Online Open House No. 2 Summary Report

**Warden Avenue and Kennedy Road
Environmental Assessment Studies between
Major Mackenzie Drive and Elgin Mills Road in
the City of Markham**

**The Regional Municipality of York
17250 Yonge Street
Newmarket ON L3Y 6Z1**

**May 2023
300052314.0000**

Preferred Design Concept - Kennedy Road - Intersections

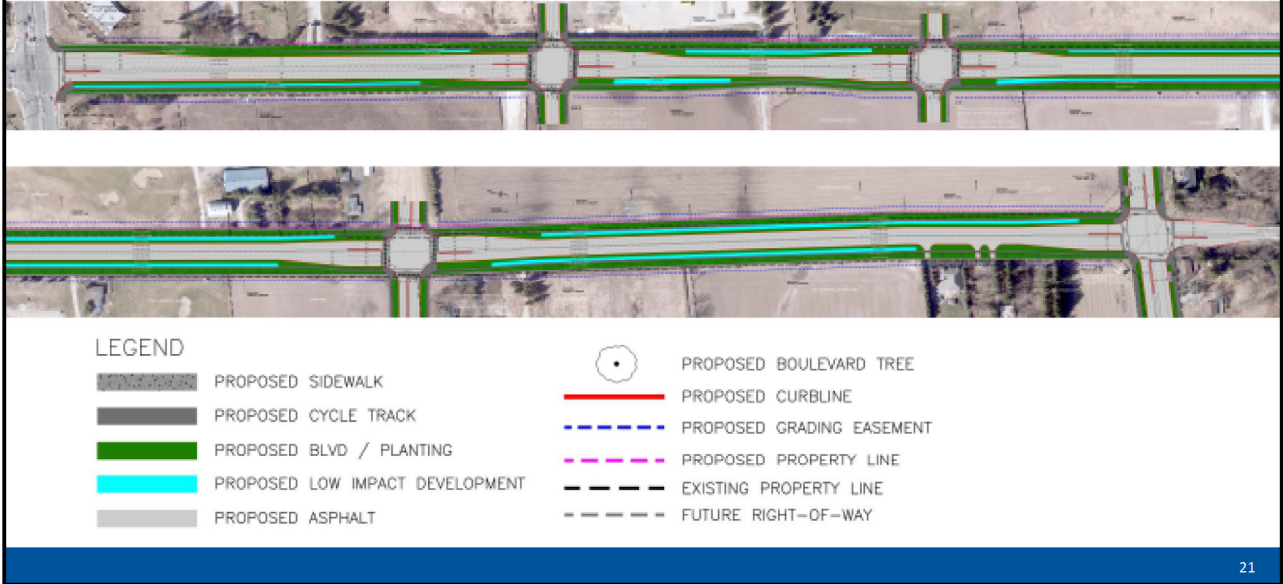
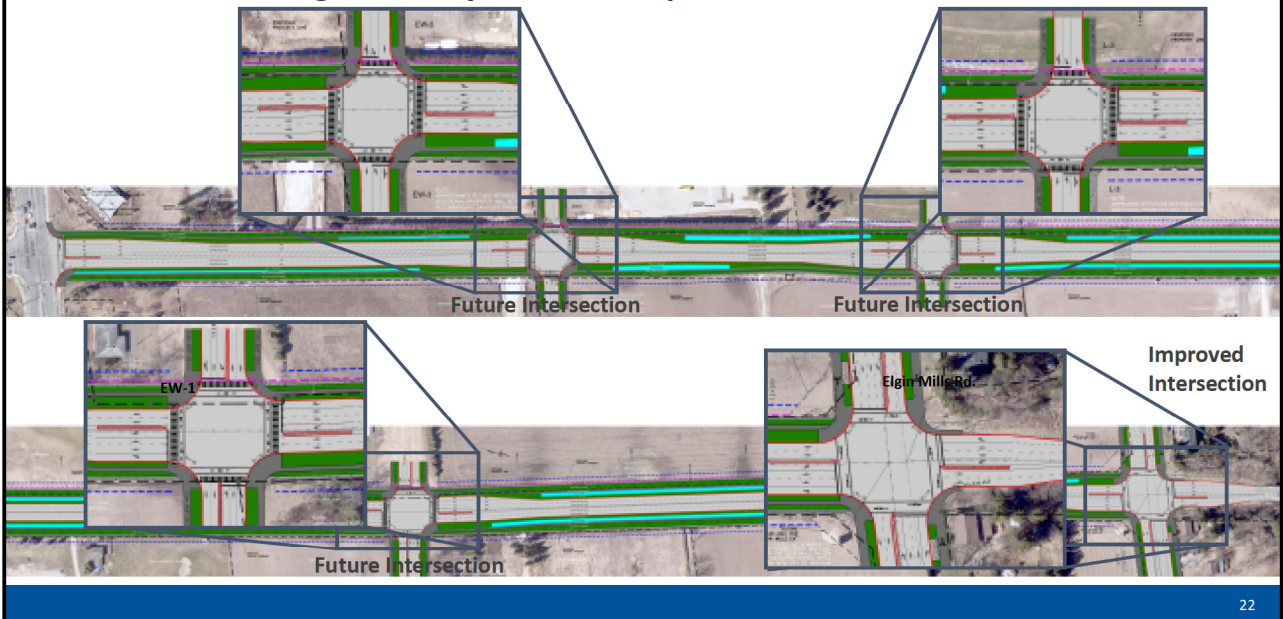
<p>Per Slides 20 and 22 of the Open House No. 2 package, the preferred intersection treatment at all five signalized intersections on each Warden Avenue and Kennedy Road is a “cross ride”. However, York Region’s Pedestrian and Cycling Planning and Design Guidelines (pages 110 to 114) discuss a preferred option; use of protected intersections with corner refuge islands. To</p>	<p>Acknowledged. The Project Team will evaluate each intersection and crossing details, balancing all user needs during the Detailed Design phase of the project.</p>

Comment	Response
quote from page 110, “The protected intersection is emerging in North America as a preferred higher order intersection treatment...” Please evaluate this concept at some or all signalized intersections.	
Although beyond the scope of this EA, York Region is encouraged to improve cycling facilities along other Regional roads and provide cycle lanes or cycle tracks, where absent. The Warden Avenue and Kennedy Road roll plans clearly illustrate glaringly absent cycling facilities beyond the EA Study Area.	The Project Team acknowledges this is beyond the scope of this EA. Connectivity and transition to existing facilities at the limits of the project is considered during Detailed Design, while also taking into consideration transition to future linkage opportunities recommended by York Region’s Transportation Master Plan and Pedestrian and Cycling Planning and Design Guidelines.
